February 6, 2023

RE: RZN 22-0004/ORD 2007- Rezoning Glade Spring Crossing, Response and Changes to staff Report

STREET A CUL DE SAC
 CONCEPT EXHIBIT

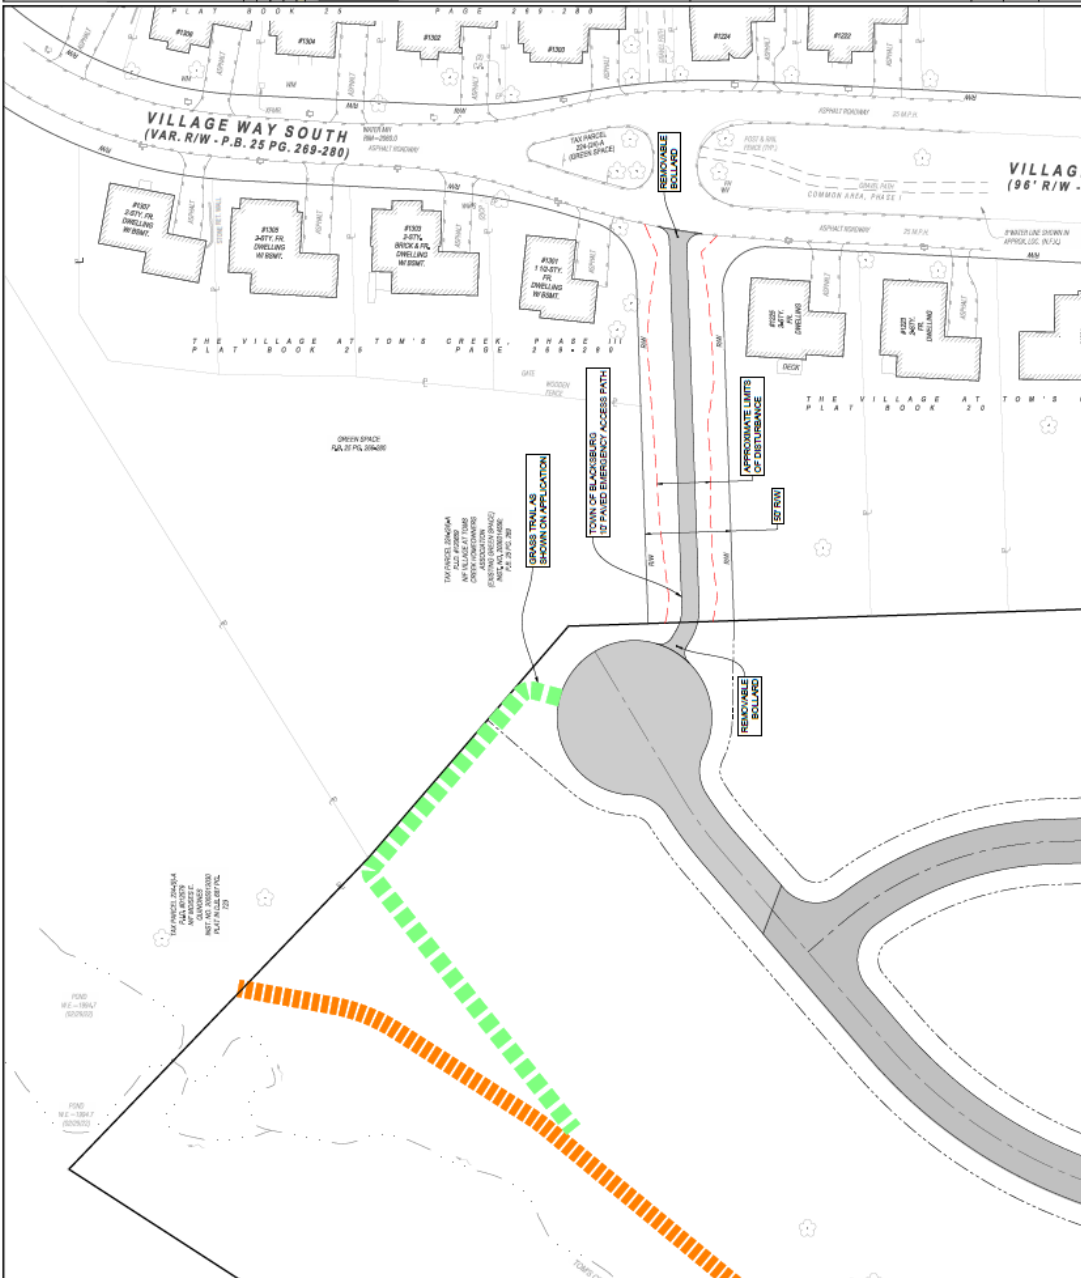
5. Neighborhood meetings and public input Responses: In response to input received, the applicant is providing an alternative to the road network. The following sketch utilizes a cul-de-sac to terminate the public right-of-way for Street A and provides an emergency access to Village Way North. The emergency access would have removable bollards at their connection with both public roads for emergency or Town maintenance vehicles. The road would be 10' wide paved and also serve as a pedestrian connection. The limits of disturbance is shown in red and are retained within the existing right-of-way. This would reduce cut-through traffic from Glade Spring Crossing into the Village at Tom's Creek and vice versa. Additionally it would provide for a pedestrian connection that cannot fit with the public road connection to Village Way South currently. The pros and cons of this design are listed below and the applicant feels that if this is perceived to be an acceptable alternative, it is a preferred alternative from the developer's perspective. The developer would be willing to obtain a variance to section 5-303 and 5-310 of the subdivision ordinance to make this feasible:

- b. Cons
 - i. Access to adjoining property Section 5-303 is not met and a variance would be required.

- ii. Cul-de-sac streets in excess of 900' would exist requiring a variance for several streets within the development from section 5-310 of the subdivision ordinance.
- iii. Vehicular traffic will travel further to get to destinations easier accessed through each other's development causing an increase to travel time.
- iv. This alternative could cause traffic from our development to use more gas and increase carbon emissions than the current alternative.

- a. Pros
 - i. No traffic issues through the Village at Tom's Creek and vice versa for Glade Spring Crossing.
 - ii. Reduces traffic pressure on Glade/Old Glade intersection and our Glade Rd. entrance as Village at Tom's Creek Traffic is additional traffic being added to those intersections.

- iii. Safety vehicles can access the North side through Village at Tom's Creek and Glade Road if blockage exists
 - iv. Less costly infrastructure for the development

- v. The development is able to retain its density.
 - vi. Provides for additional pedestrian connectivity "out of the street" between neighborhoods which was desired by residents and Corridor Committee.

- vii. Eliminates landing and slope variances for public road.
 - viii. Less traffic along Road A in GSC
 - ix. Does not require permission outside of the right-of-way to construct
